CNRO-2002-00022

**SUBJECT:** Entergy Operations, Inc.  
Response to NRC Request for Additional Information Regarding  
Proposed Alternatives to ASME Requirements for Weld Repairs (TAC  
Nos. MB4286, MB4288, and MB4289)

**RESPONSE TO NRC REQUEST FOR ADDITIONAL INFORMATION  
PERTAINING TO REQUEST No. PWR-R&R-001, Rev. 0  
(TAC Nos. MB4286, MB4288, and MB4289) DATED MARCH 28, 2002**

**REQUEST No. PWR-R&R-001, Rev. 0**

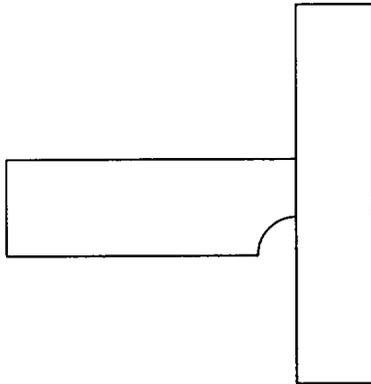
2. Assuming IWA-4530 applies, it has a limitation: "The repairs to a completed joint shall not exceed one-half the joint thickness. The surface of the completed repair shall not exceed 100 sq. in." From the descriptions of Figures 2 and 3 of the submittal dated March 29, 2002, the repairs could extend through-wall. Explain why Code limited repairs to one-half the joint thickness. What are the concerns with a through-wall temper bead repair?

*Entergy has deleted temper bead repairs of RPV penetration nozzle base materials from PWR-R&R-001 to clarify that it only applies to ambient temperature temper bead weld repairs of the J-weld. Entergy is not proposing a through-wall repair. Although the proposed weld repair may be a full throat or full depth repair of the partial penetration J-weld, it is not through-wall as explained below.*

Partial Penetration J-Weld

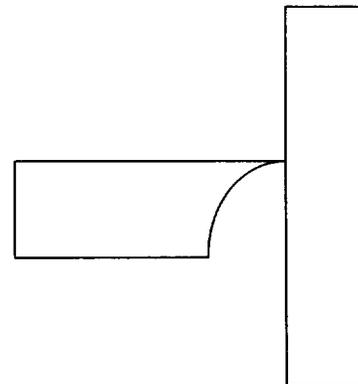
A "joint" is the junction of members to be welded irrespective of weld type (i.e. single bevel groove, double V-groove, J-groove, etc.) or depth of weld penetration (i.e. partial penetration or full penetration) in the joint. "Joint penetration" defines the depth of weld penetration in a joint. Full penetration welds penetrate the full length or depth of the adjoining members in a joint. Partial penetration welds only partially penetrate through the joint such that part of the joint remains unwelded. Examples of partial and full penetration J-welds in a "T-Joint" are shown below.

The "joint" between the RPV head and each RPV penetration nozzle is best described as a T-Joint. The weld that attaches each RPV penetration nozzle to the RPV head is a partial penetration J-weld. Examples of partial penetration welds are shown in NB-4244(d)-1 of ASME Section III. The J-weld throat dimensions at ANO-1, ANO-2, and Waterford 3 are substantially less than one-half the joint thickness. Therefore, a full throat or full depth J-weld repair can be performed and not exceed the depth restriction of IWA-4330. See Response to Question 7 for additional information.

**Typical RPV Head Penetration Nozzle**

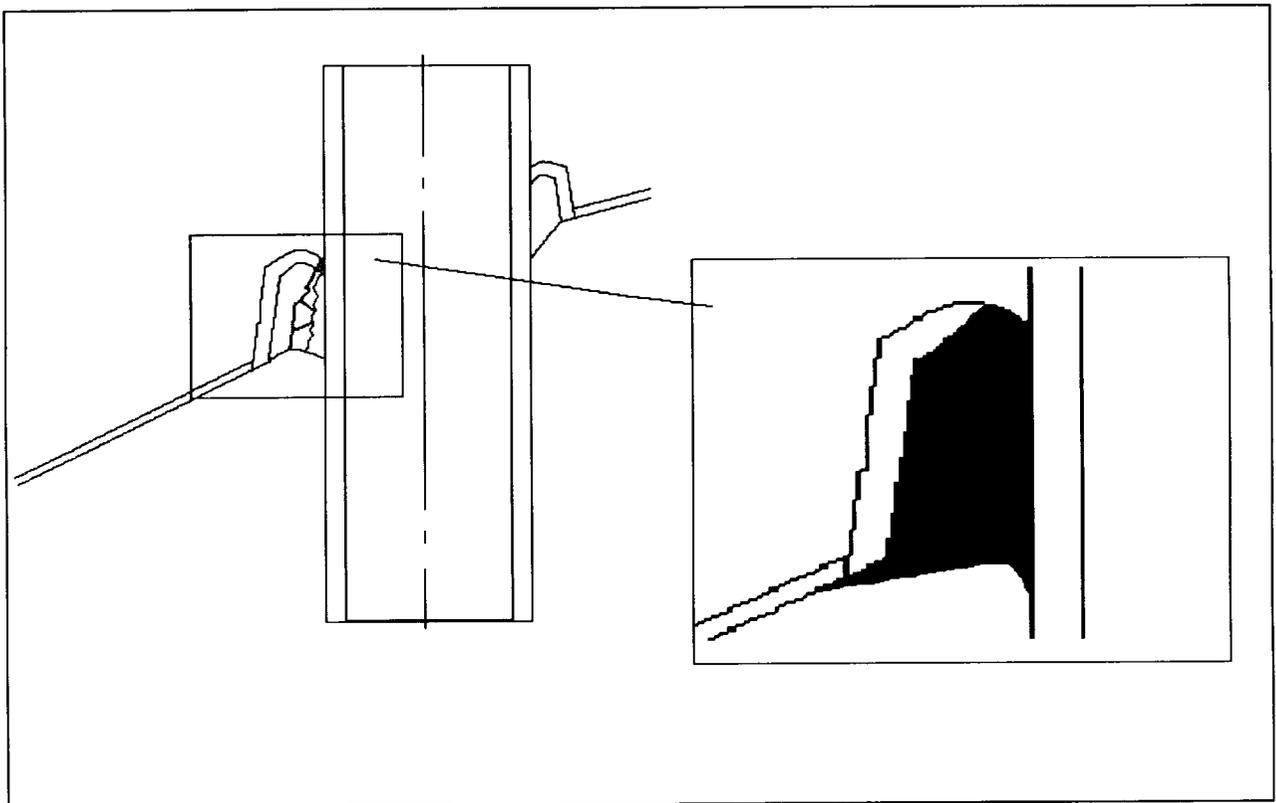
4. Please provide a discussion and cross-sectional sketch of the weld repair.

*Entergy has provided sketches depicting a typical RPV head penetration nozzle (Figure 1) and an example repair of an RPV head penetration nozzle J-weld (Figure 2) in revised PWR-R&R-001. Entergy has deleted temper bead repairs of RPV head penetration nozzle base material from PWR-R&R-001.*

*Entergy has provided sketches depicting a typical RPV head penetration nozzle (Figure 1) and an example repair of an RPV head penetration nozzle J-weld (Figure 2) in revised PWR-R&R-001.*
